ACCESS REPORT

Independent living units for seniors living
29-35 Lochnivar Road, Revesby NSW

Prepared for
DTA Architects

Reference No.
24132-DA

LONGITUDINAL SECTION
HORIZONTAL: 1 : 200
VERTICAL: 1 : 200

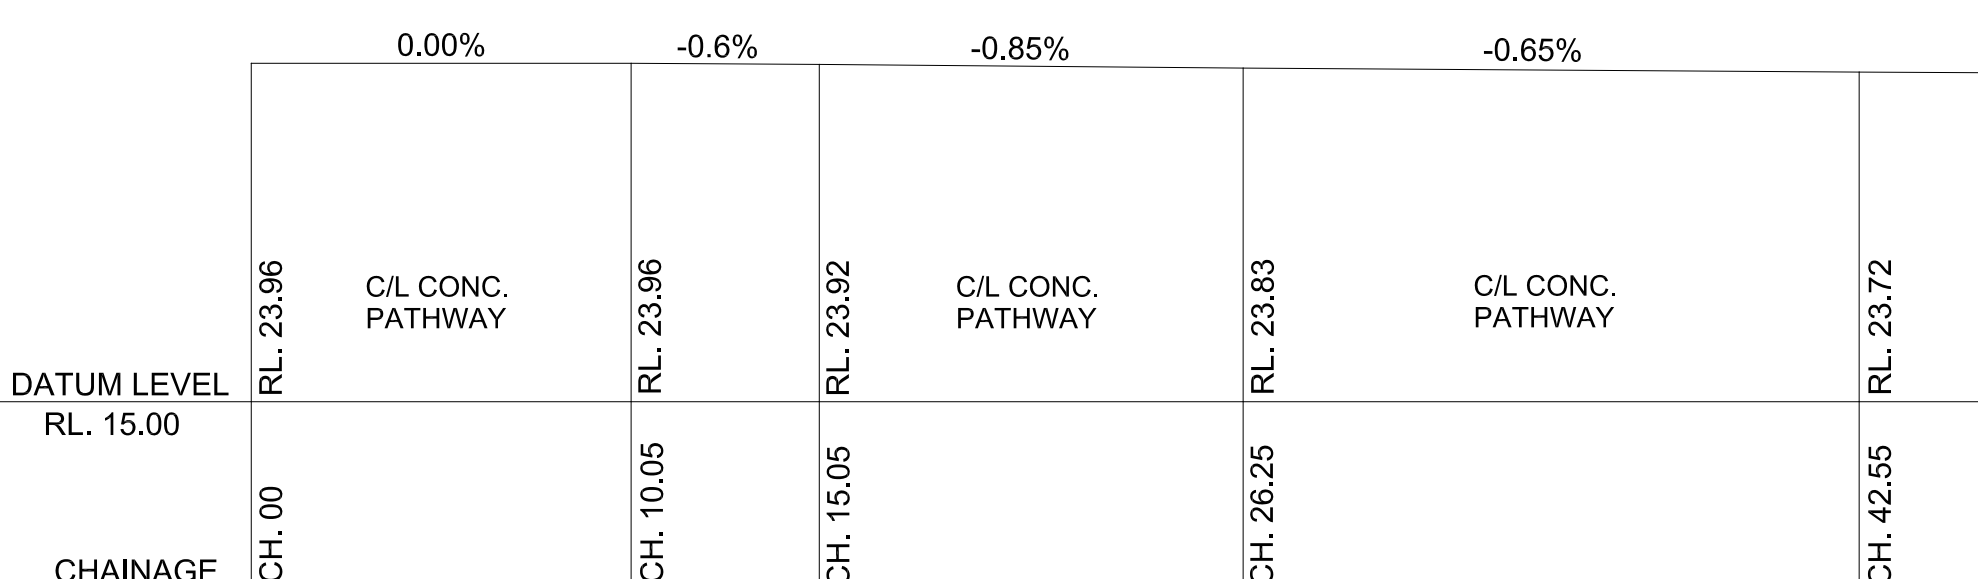
The footpath on the driveway for 17 Kennedy St appears to be damaged (based on Google street view).

Footpath must be rectified to provide safe travel.

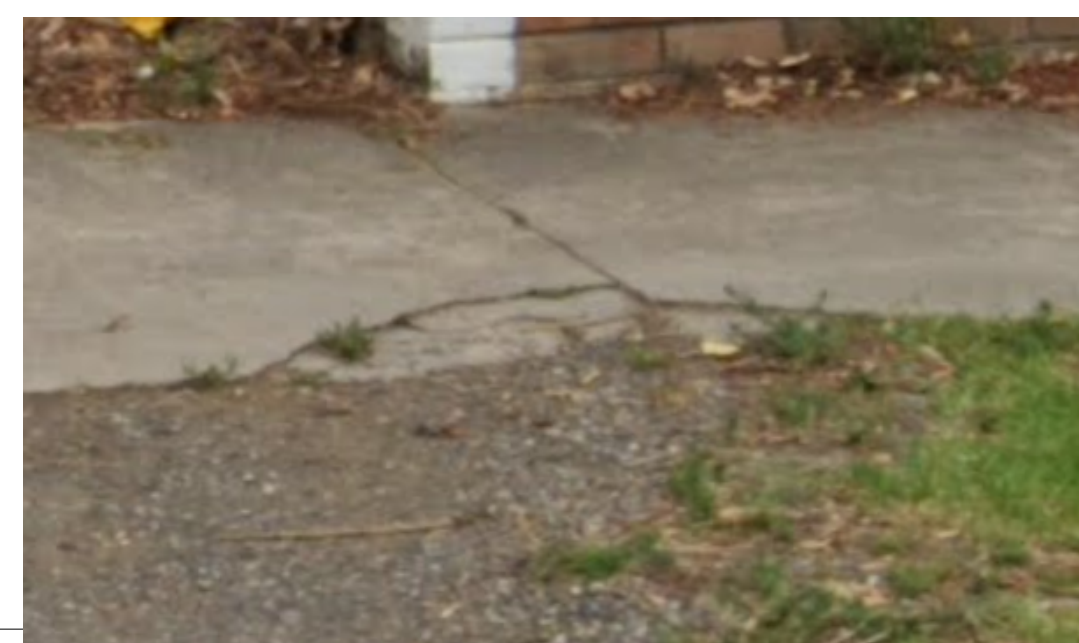
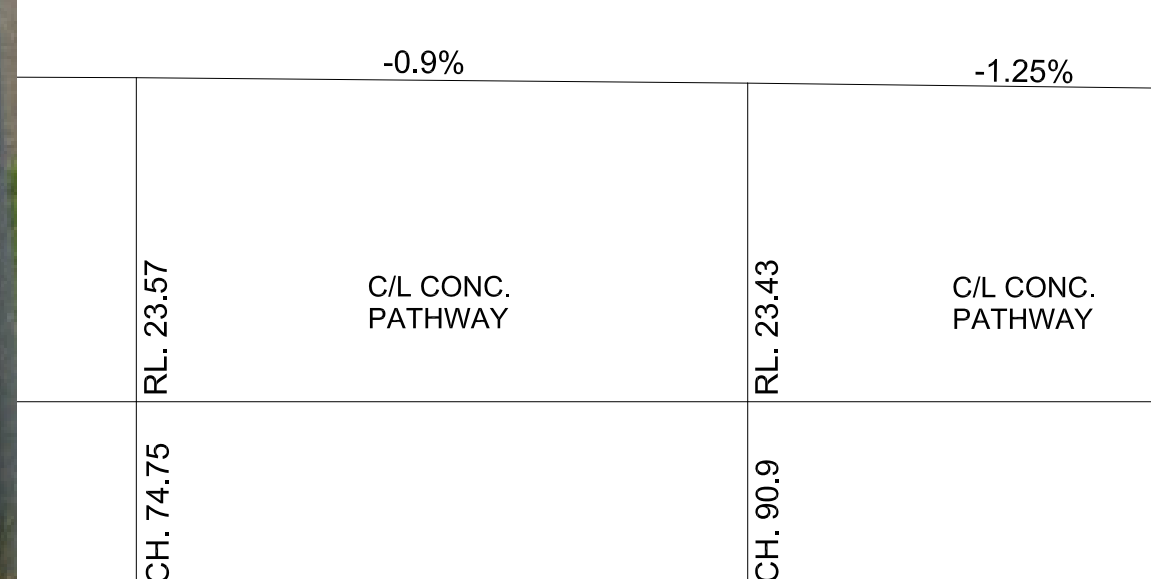
Footpath appears to be damaged at the bend.

Footpath must be rectified to provide safe travel.

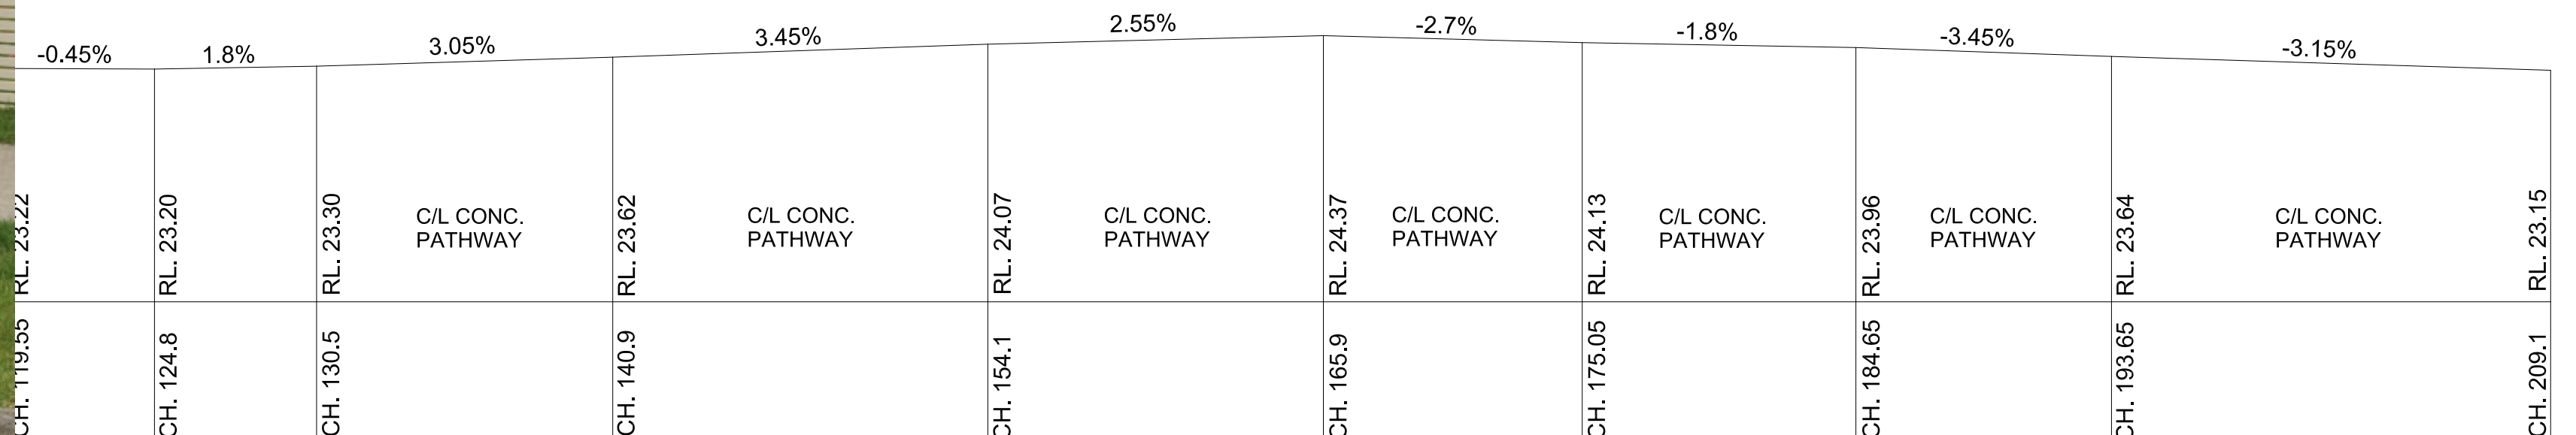
Bus stop 2 is within a nature strip (based on Google street view).

Need a sealed footpath similar to Bus stop 1
